**Regular Meeting of the Planning Commission**

**ITEM DESCRIPTION: ZONING CASE 23-07: SITE PLAN STRACK  
CONSTRUCTION FOR C&L DISTRIBUTION LOCATED  
NORTHWEST OF HIGHWAY 33 AND STARK ROAD**

### MEMO

**SUBJECT:** C & L Distributing - Grading permit application review

DRAWING NO:  
**A1.0**

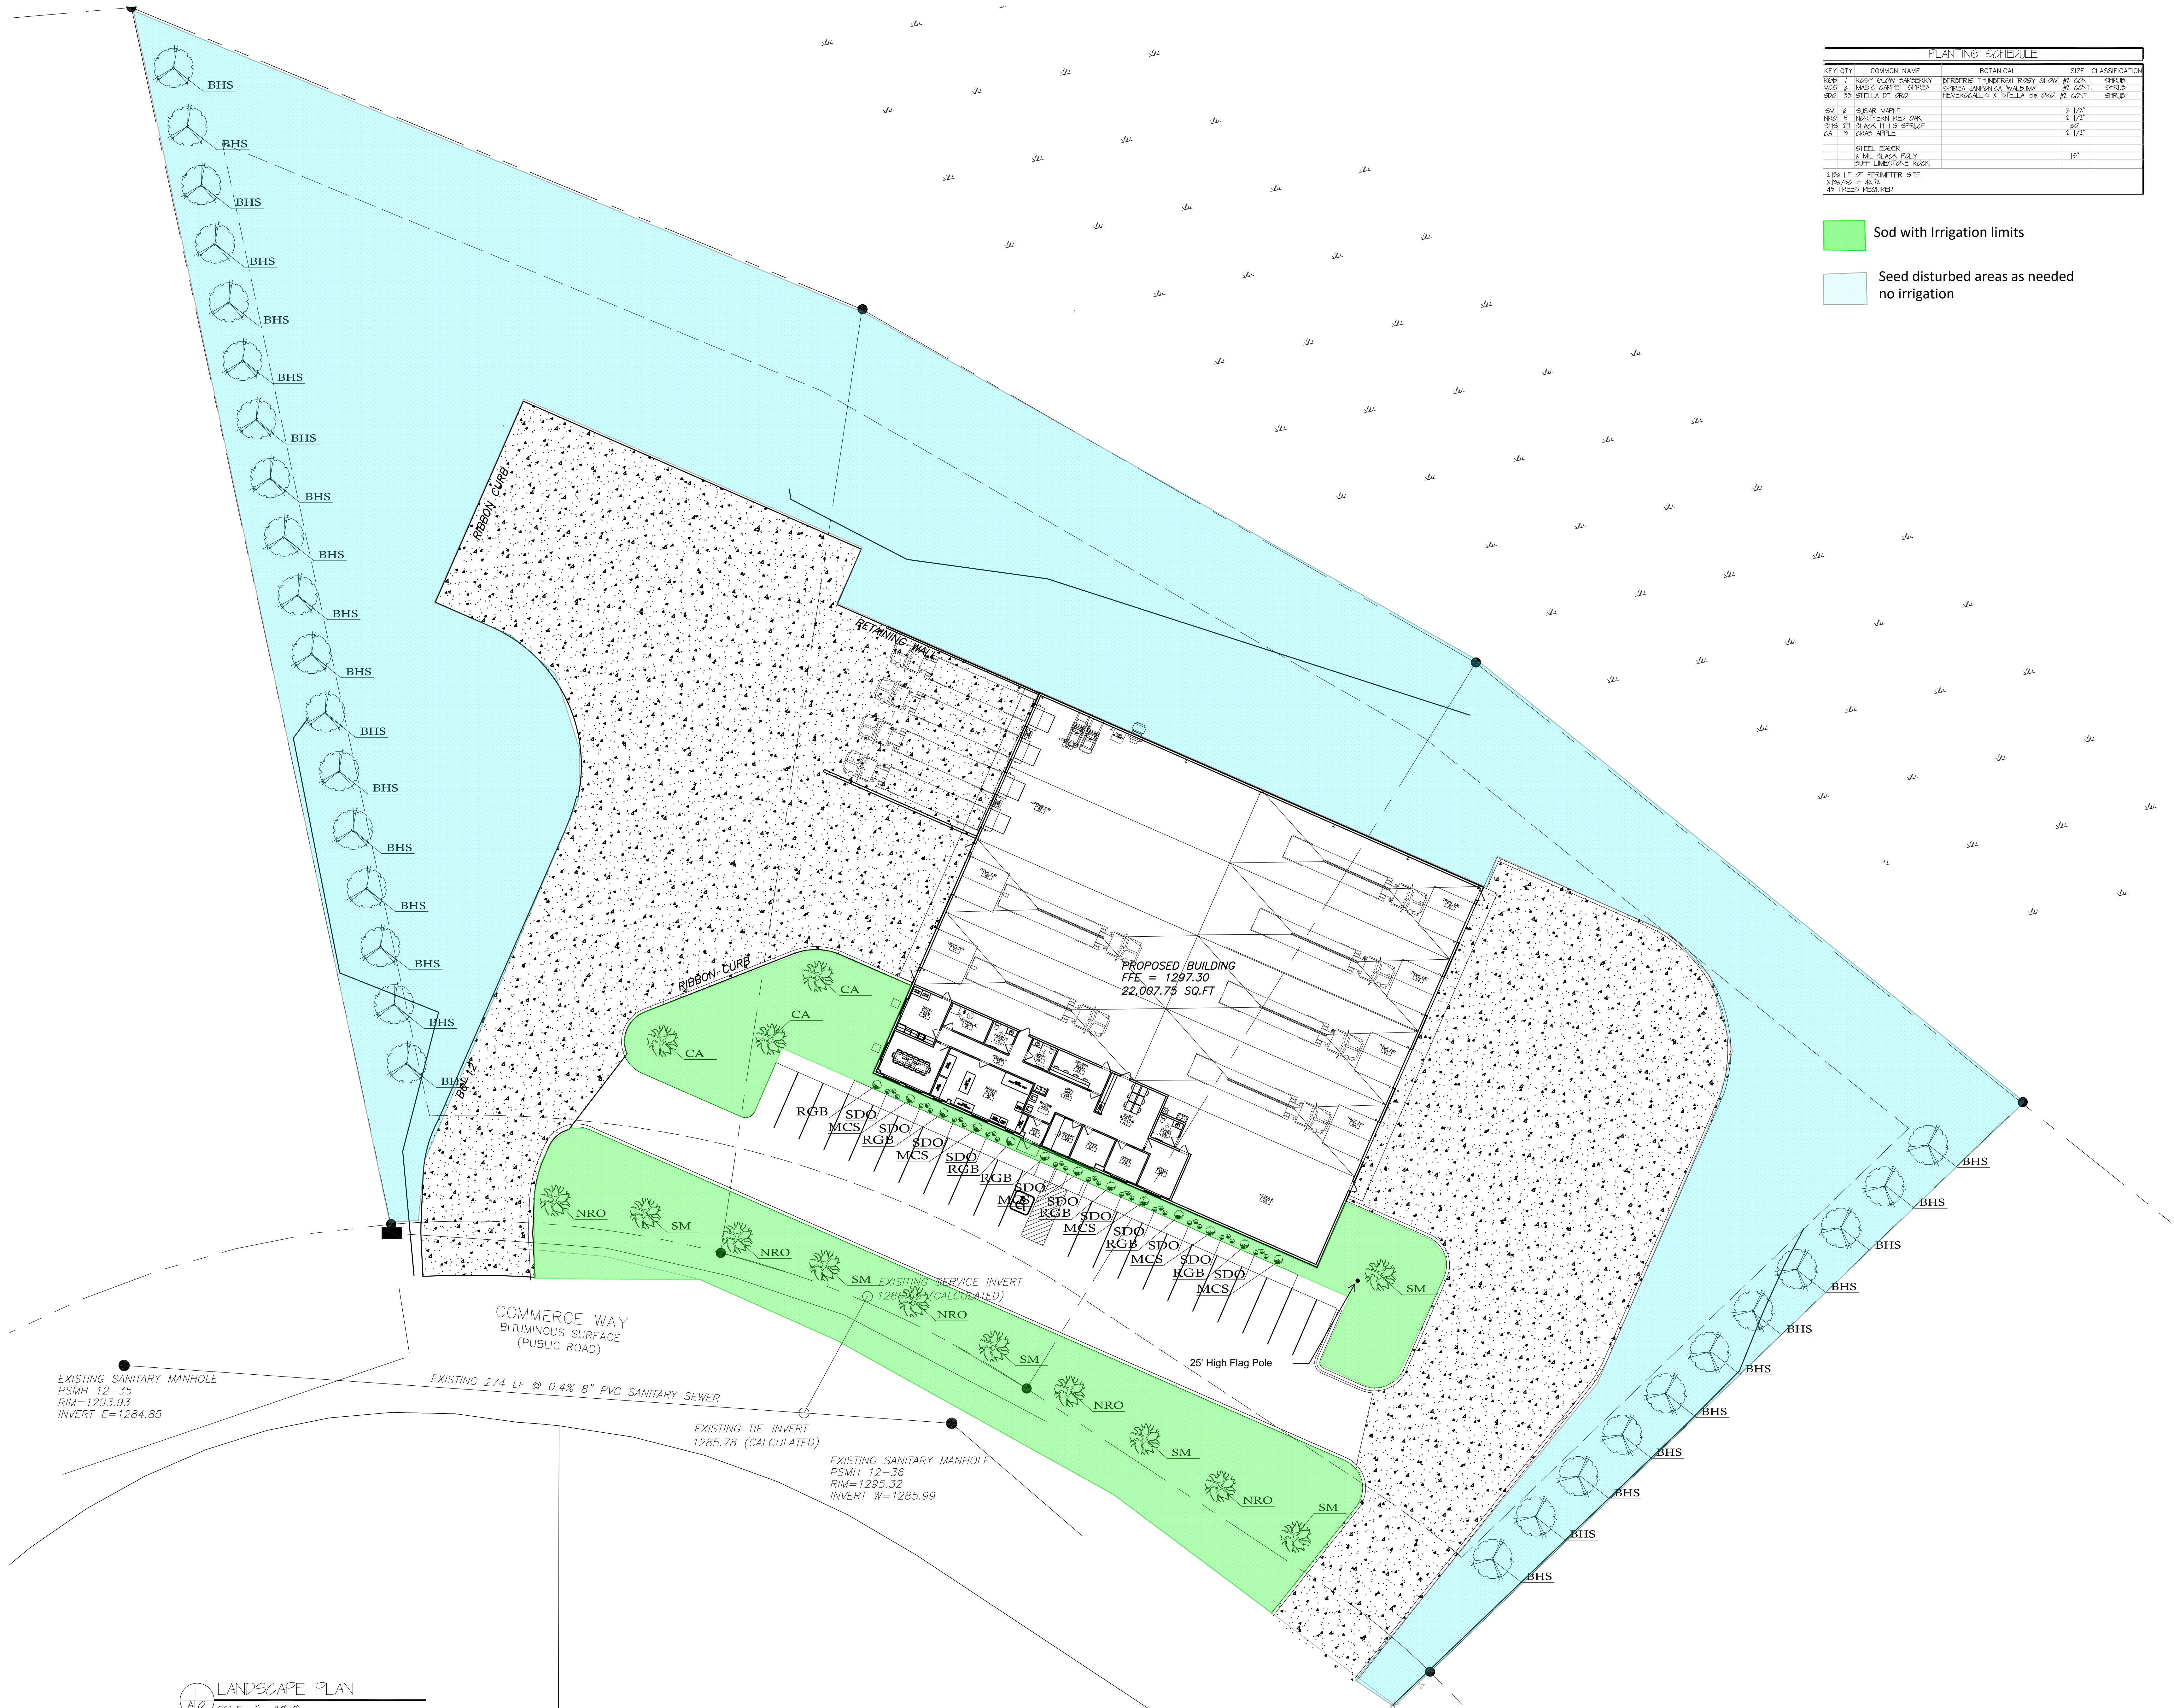
28. The southerly two or three trees shown along the east property line look to be shown in the bottom of the drainage swale and may interfere with operation and maintenance of the swale.
29. The trees along Commerce Way should be spaced so as to not place trees directly over the sewer or water services.
